# North Haiwee Dam No. 2 Project

## Final Environmental Impact Report/ Environmental Assessment

**May 2018**

Figure 2-7 Construction Schedule by Alternative

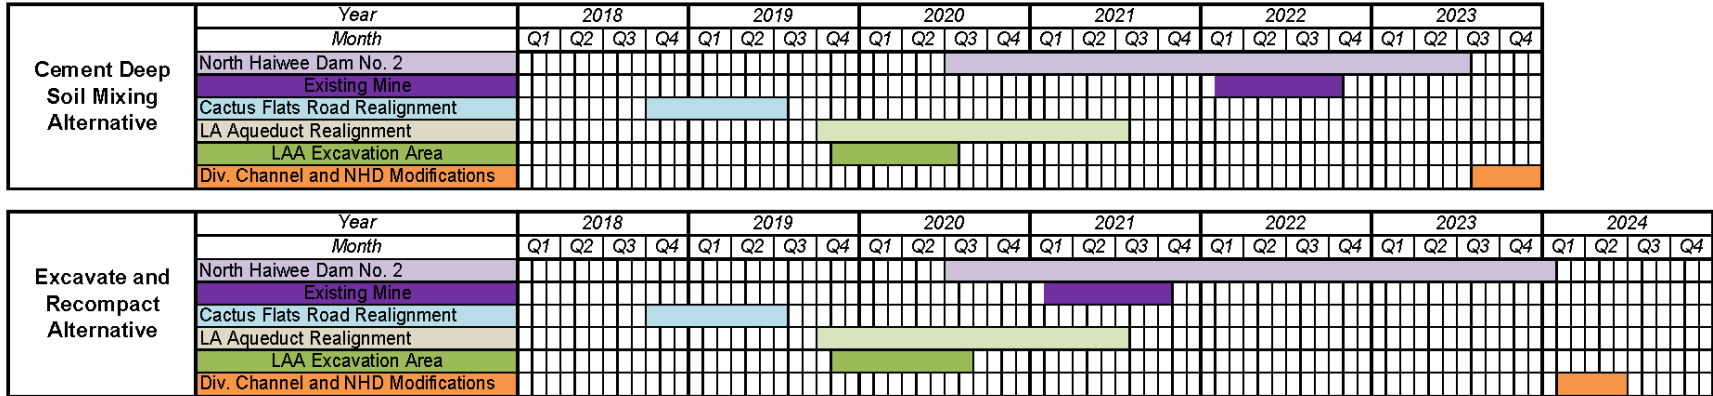
2-15	<p><i>Due to project refinements, the construction schedule for the CDSM Alternative and Excavate and Recompect Alternative has been updated to reflect a more accurate start date. As such, Figure 2-7, Construction Schedule by Alternative, is modified on the following page:</i></p>
